TRANSPORT TECHNICAL NOTE

**Outline planning permission for the construction of 18No dwellings with associated infrastructure
(some matters reserved except for access and layout)**

**Land at Barton Lane, Congerstone, Leicestershire.
Current Planning Application No: - 23/00978/OUT.**

MARCH 2024

LTP Vehicular Access Design

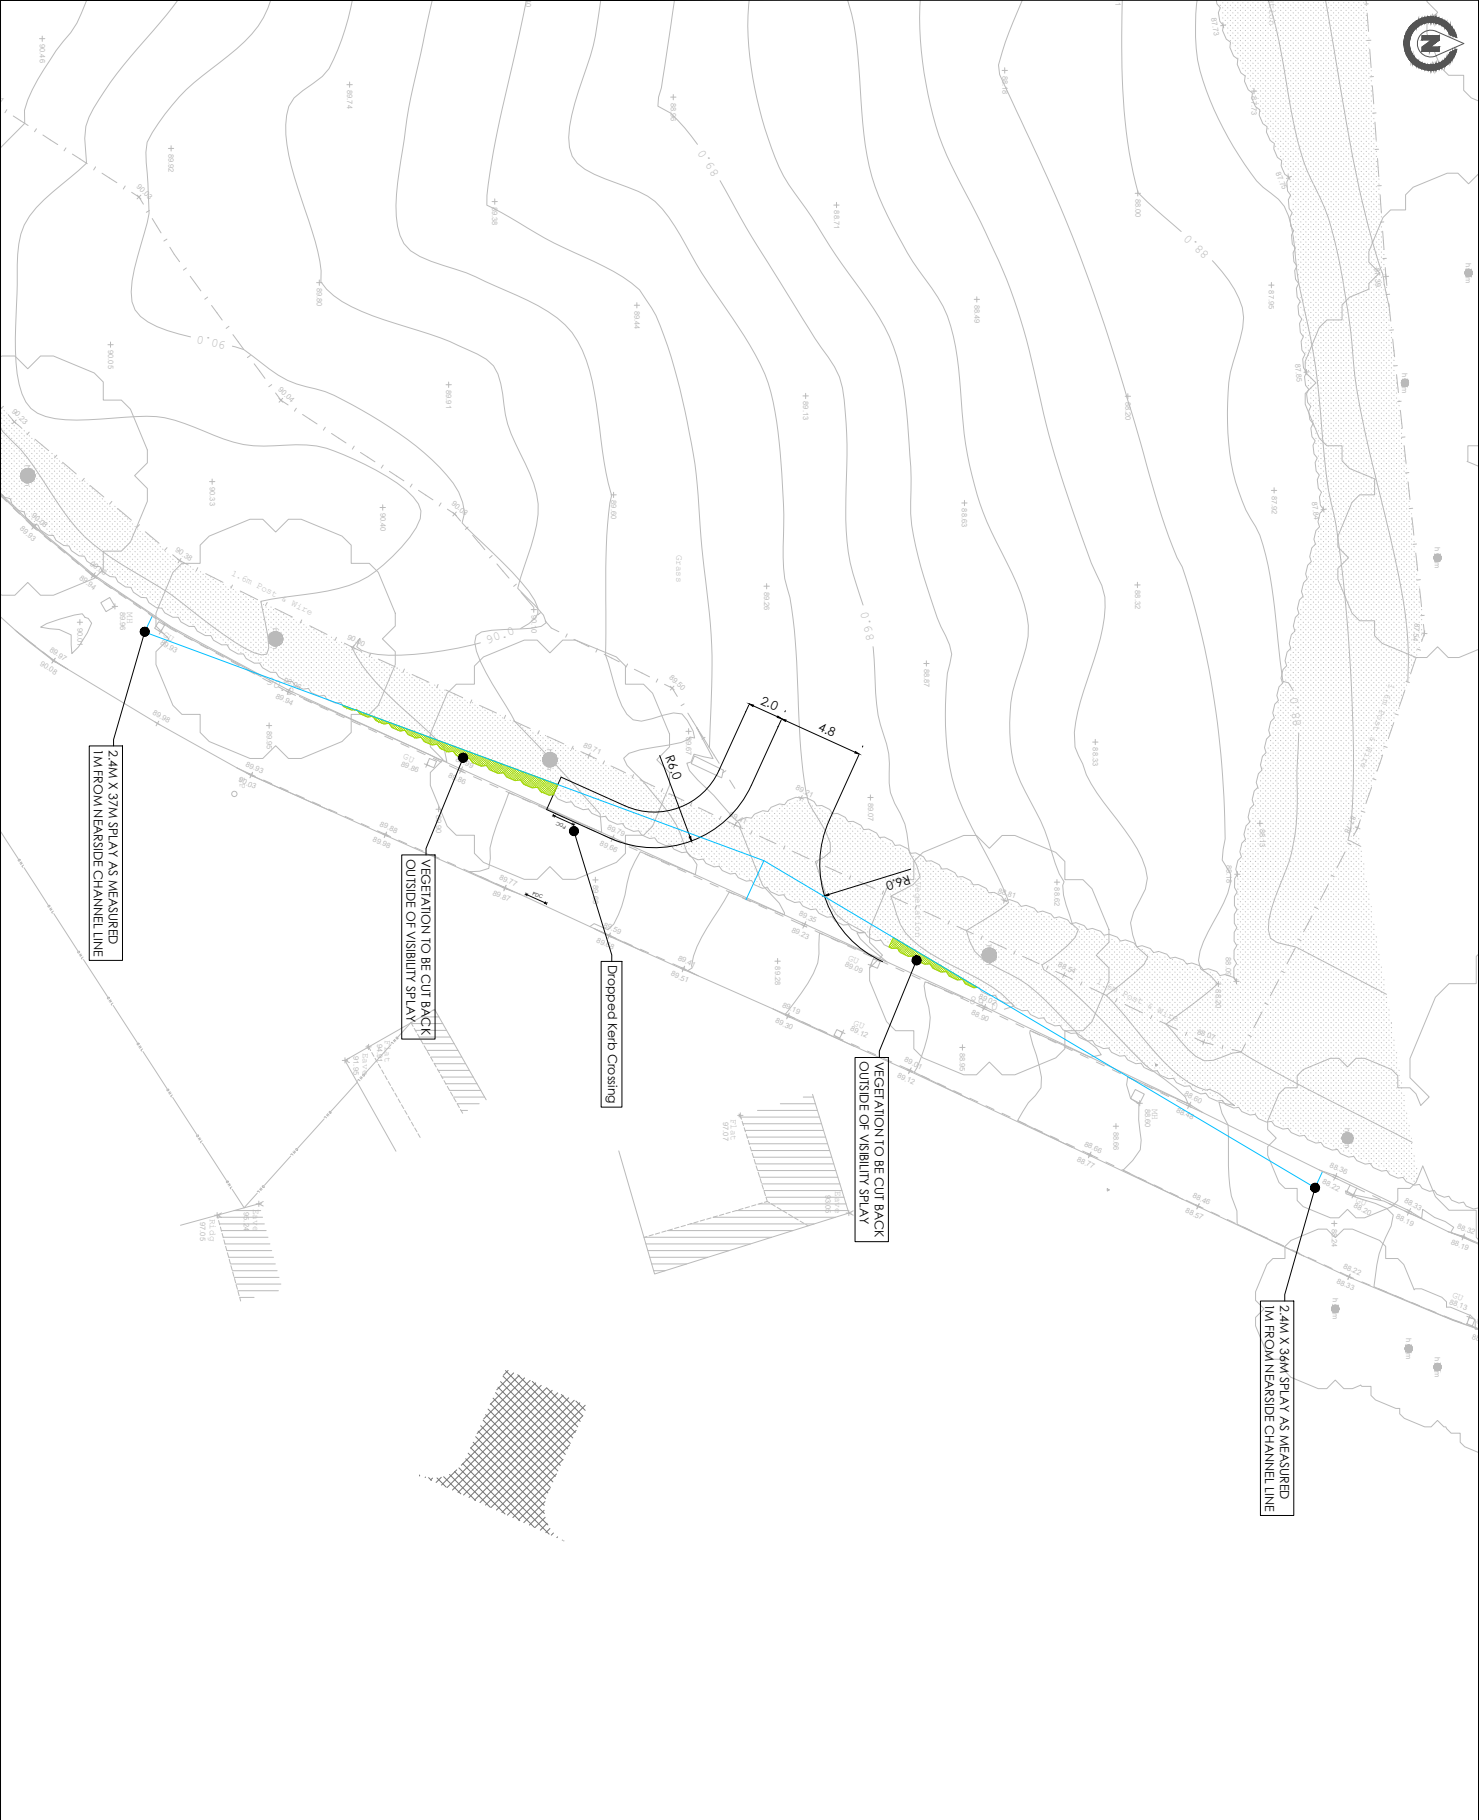
The LHA have reviewed plan 'Access Design', drawing number NE/0312/AD/23 Rev C. The LHA are satisfied that this accords with Figure DG20 of Part 3 of the Leicestershire Highway Design Guide (LHDG) in terms of minimum effective access width for a distance

'Whilst the LHA also agree with the MfS2 formula as set out in Section 4.3 of the Transport Statement, the LHA find that dry weather visibility splays of 2.4m by 36m (rounded up from 35.69m) should be provided based upon MfS2 calculations to the north of the access, and 2.4m by 37m (rounded up from 36.63m) to the south. As such, the Applicant should provide a revised scaled access drawing that demonstrates the above.'

Plan 'Access Design', drawing number NE/0312/AD/23 Rev C demonstrates the above and is therefore acceptable in these site specific circumstances.

Prior to the formation of this note, Mr Wiggins (Planning Agent) submitted the LTP vehicular access arrangement drawing No:- NE/0312/AD/23 Rev C to the LPA for their consideration. The LHA were then consulted hence the comments above. For completeness a copy of the drawing is attached at Appendix C. Based on the LHA comments above, we suggest that it is now common ground that an acceptable form of vehicular access arrangement has been demonstrated and agreed as set out in that drawing.

Vehicle Swept Path Analysis

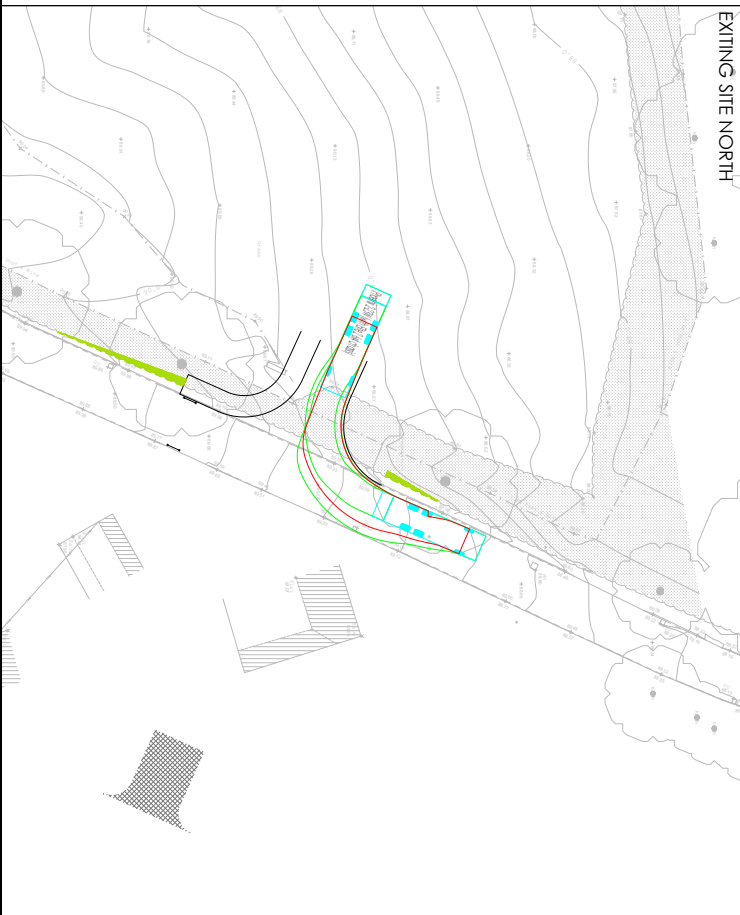
The LHA previously requested an Independent Stage 1 Road Safety Audit (RSA) and accompanying Designer's Response, it does not appear that one has been provided. Given there are engineering works to connect to the site to the public highway this is required. The brief should include all the access drawings including plan 'Vehicle Tracking', drawing number NE/0312/AD/23. The LHA have concerns regarding overrun of

the footway at the location of the proposed uncontrolled pedestrian crossing by refuse vehicles exiting the site.

LTP can now confirm that all internal roads will remain private and not be offered for road adoption. Accordingly, the private drive is not subject to such a requirement for bend widening. All vehicles will be able to enter and leave the highway in a forward gear as vehicle turning will be provided within the site. Vehicle swept path analysis has been carried out for the Authority standard refuse vehicle at the vehicular access to demonstrate the access works satisfactorily (see **Appendix E**).
